Product Announcement

December 14, 2007

PCORE Improves Oil-Level Visibility in POC® Bushings

New Fluted Sight Glass

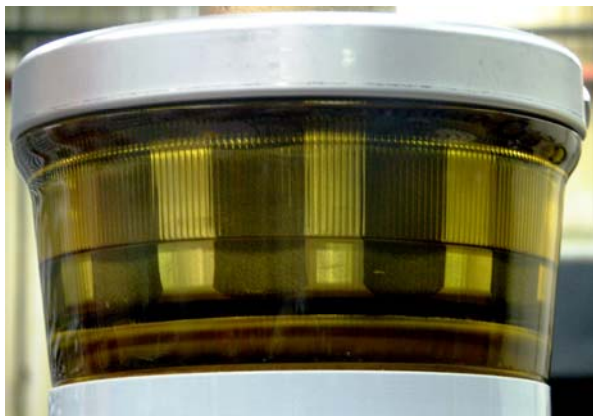
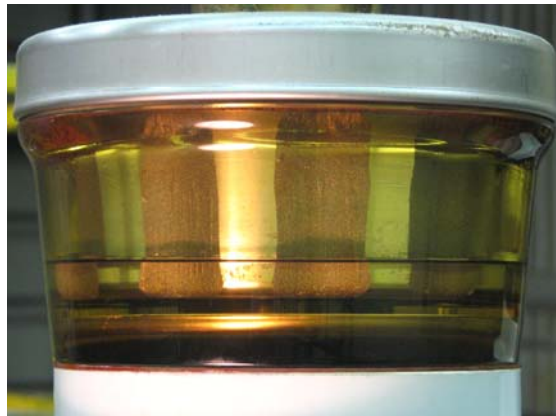
PCORE Electric has announced that beginning in the 1st Quarter of 2008, sight glasses on their POC® (Paper-Oil-Capacitor) bushings in the Series II & 88 Series product lines will use a new clear-view oil reservoir component.

The oil reservoir will be manufactured with a fluted interior surface contour instead of the current smooth interior surface. This feature was recommended by our glass suppliers as we searched for a design that would allow our customers to more easily see the oil level in their PCORE® bushings under difficult viewing conditions.

This fluted design has been employed for many years in the United States, which includes usage in PCORE 1175 BIL designs. Other than visibility, there are no functional differences in the two sight glass types.

In an effort to avoid visual differences within orders, units purchased in specific lot sizes will be shipped with the same glass type, either fluted or non-fluted, until the transition is complete.
